ND-18-0106
10 CFR 50.90
10 CFR 52.63

Southern Nuclear Operating Company
Vogtle Electric Generating Plant Units 3 and 4
Request for License Amendment and Exemption:
Changes to the Building Gap between the Nuclear Island and Adjacent Buildings (LAR-18-002)

Request for License Amendment: Changes to the Building Gap between the Nuclear Island and Adjacent Buildings (LAR-18-002)

Figure 1: Illustrative Sketch of the Nuclear Island and Annex/Turbine Buildings Displacements during an SSE

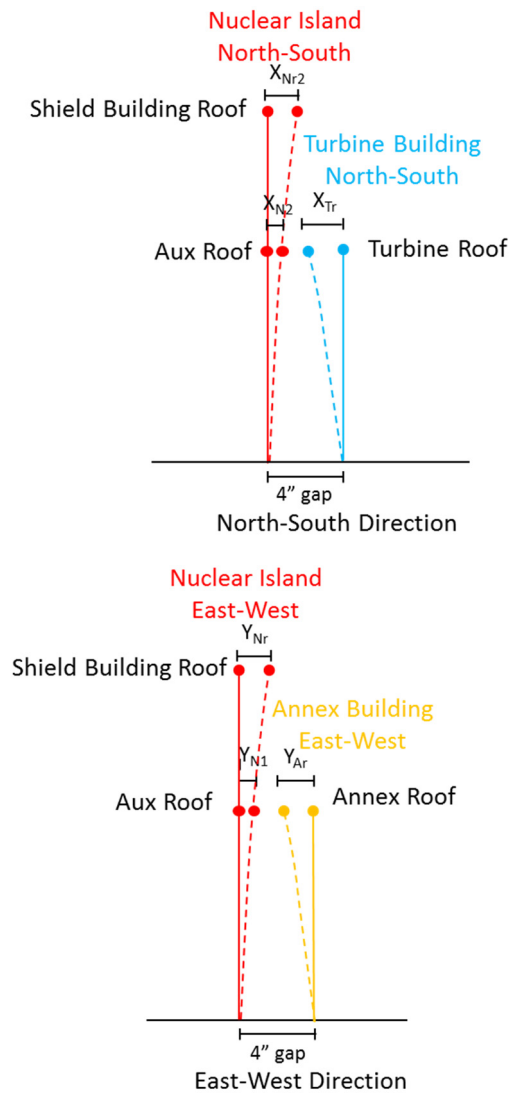
The proposed change is to relax the minimum gap requirement above grade in the licensing basis between the nuclear island and the annex building/turbine building from a 4 inch minimum gap to a 3 inch minimum gap in COL Appendix C ITAAC No. 3.3.00.13, UFSAR Appendix 2.5E Section 5.2 and UFSAR Subsections 3.7.2.8.1 and 3.8.5.1. Due to the 1 inch reduction in the minimum gap above grade, the maximum relative displacement between the roof of the nuclear island and the annex building/turbine building described in UFSAR Subsection 3.8.5.1 is changed from less than 3 inches to less than 2 inches. The maximum relative seismic displacement between the nuclear island and the annex building/turbine building was analyzed to be less than 2 inches; therefore, the reduction of the seismic gap requirement does not affect the requirement to maintain a 1 inch minimum gap during SSE events in UFSAR Subsection 3.8.5.1.

The current licensing basis, including COL Appendix C ITAAC No. 3.3.00.13, UFSAR Appendix 2.5E Section 5.2 and UFSAR Subsections 3.7.2.8.1, 3.7.2.8.2 and 3.8.5.1, defines a minimum 4 inch gap above grade between the nuclear island and adjoining buildings. The purpose of the gap is to avoid contact between the nuclear island and seismic Category II structures (annex building/turbine building) when the buildings deflect during an SSE event. The seismic response analyses, including soil-structure interaction between the nuclear island and the adjoining building, are performed using the System for Analysis of Soil-Structure Interaction (SASSI) program. The maximum relative seismic displacement is established from the 2D SASSI analyses, as specified in UFSAR 3.7.2.8.4. The SASSI models consist of soil profiles and properties, basemat models and structure models, which include the coupled auxiliary and shield building stick model, containment internal structures stick model and steel containment vessel stick model. The SASSI models also include the annex building East-West and the turbine building first bay as stick models. Previous design changes are incorporated into the latest AP1000 generic 2D SASSI analysis, including changes to the nuclear island (e.g., polar crane mass change) and adjacent buildings (e.g., change of structures of turbine building first bay). The latest AP1000 generic 2D SASSI analyses show that the maximum relative seismic displacement between the annex building and the nuclear island is 0.95 inches, and between the turbine building and the nuclear island is 1.04 inches, which are both less than the 2 inch maximum relative seismic displacement requirement. The illustrative sketch of building deflections under an SSE is shown in Figure 1 below. Table 1 is also provided to summarize the current and proposed licensing requirements, and the values in the calculations which support the proposed licensing change.

The analyses results support the requirement that the maximum relative seismic displacement between the roof of the nuclear island and any adjoining buildings is less than 2 inches. The proposed change reduces the minimum gap requirement between the nuclear island and the annex building/turbine building to 3 inches, which leaves at least a 1 inch gap between the nuclear island and the annex building/turbine building during a seismic event. Therefore, the proposed change to the gap requirement does not reduce the 1 inch gap margin in a seismic event, as specified in UFSAR Subsection 3.8.5.1. The proposed change to the gap requirement does not affect the structural integrity requirements on seismic Category I structures. The safety functions of the seismic Category I structures are not impacted. The performance of the seismic Category II structures is not impacted and will not degrade the function of a seismic Category I structure, system or component.
